Section 92 Request Response Table

Site / Project	Dominion and Valley	Last Updated	8/10/2024
----------------	---------------------	--------------	-----------

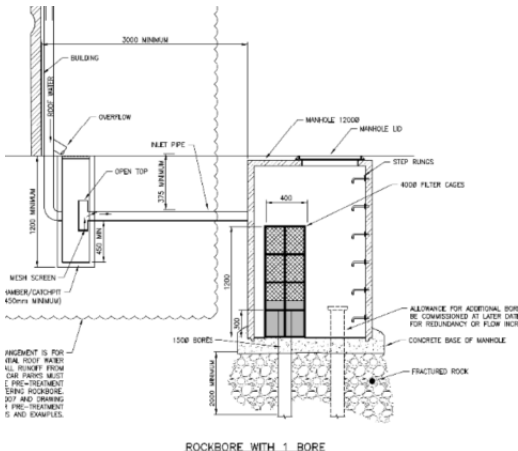
1b.	<p><i>For 1% flows</i></p> <p>It is important first applicant assesses and addresses the effects of 100% flows discharged to the ground. It should be noted that Auckland council central part if considered soakage area and council's s/w CoP and GD07 is expecting this area should be used for disposal of 10% flows</p>	<p>The proposed 1% AEP peak flow to the aquifer is 33 l/s. This flow is very small compared to size and capacity of underlying aquifer.</p> <p>The proposed volume discharge to aquifer in 1% AEP event is 240m³. For the historic pre-developed grassed site, the volume discharged from site to the aquifer would</p>

Section 92 Item		Action / Response
	<p>into the ground. Discharging 1% flows will certainly have limitations as well as effects on subsoil storage. Hence, it can be said that the 10% discharging ability to the ground may be compromised due to 1% discharge. It should be noted and clarified in the meeting that if the aquifer conditions change and have full capacity then hazard such as flood will remain unserved, and it will have more effects down the lifetime. Hence discharging the 1% flow into the soakage is not considered acceptable until and unless applicant proves that it is sustainable way for lifetime of the development without the effects on environment. This is needed.</p> <p>For 1% flows, we need separate assessment which can demonstrate how the storage is being arranged and managed as alternate to the compromised storage due to the proposed development. We also need to see how the flows will be transferred to storage and will operate during 1% flood event. Similarly, the storage will also be working during 10% flows so how this will be working.</p>	<p>have been approx. 670m³. For the 5 ha upstream catchment, the total volume being discharged to the aquifer is approx. 3,500m³. The geotechnical investigations also indicate that groundwater is approximately 20m below ground surface indicating significant capacity in the basalt materials. Based on above, we expect the aquifer would have ample capacity for the partial 1% AEP flow from the site.</p>

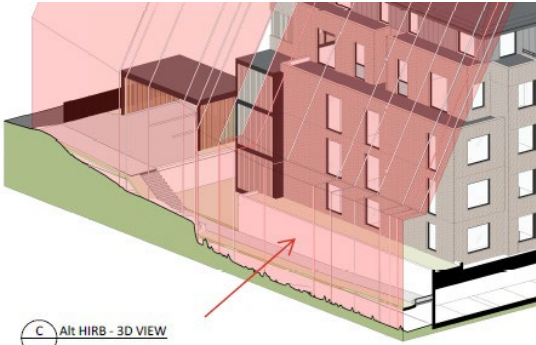
4.	<p>It is mentioned in provided flood assessment that the OLF entering from eastern boundary (>8500m² catchment & 0.332m³/s flow rate) will be blocked because currently upstream neighbour is blocking it. This approach is considered no acceptable. There is highest possibility in future that the neighbour develops the property with allowing the OLF to pass to the subject property (maintaining entry and exit as per AUP) then this development will be a cause of obstruction. It is also important to be noted that the neighbour properties might be developed in past when there was no appropriate information about the OLF / flood available which is not the present case. Hence, it is expected applicant assesses their proposal based on the OLF entering into their property</p>	<p>Eastern OLFP Council's concerns acknowledged. It is now proposed to allow for eastern OLFP to discharge onto site. Once it has entered the site it will add to flow into ponding area in the eastern area of the site and once the ponding reaches RL 52.4 m the flows will then discharge out onto Valley Road.</p> <p>Northern OLFP There is a landscape area and footpath along the northern side of the building that is approximately 300 mm lower than the neighbouring property. This area is 2.6 m wide with a 0.6% longitudinal fall eastwards. See snip below from our drawing C04.</p>

The overland flows are expected to be diverted along the eastern side to the road. It is important we have all details that show how the existing OLF will be collected inside the boundary into the proposed flow path channel, how it will work and will be maintained and how it will discharge the flow to the exit.

The north-western OLFP does not meet AUP definition as the upstream catchment is less than 4,000 m2. Therefore, AUP OLFP controls do not apply and development does not need
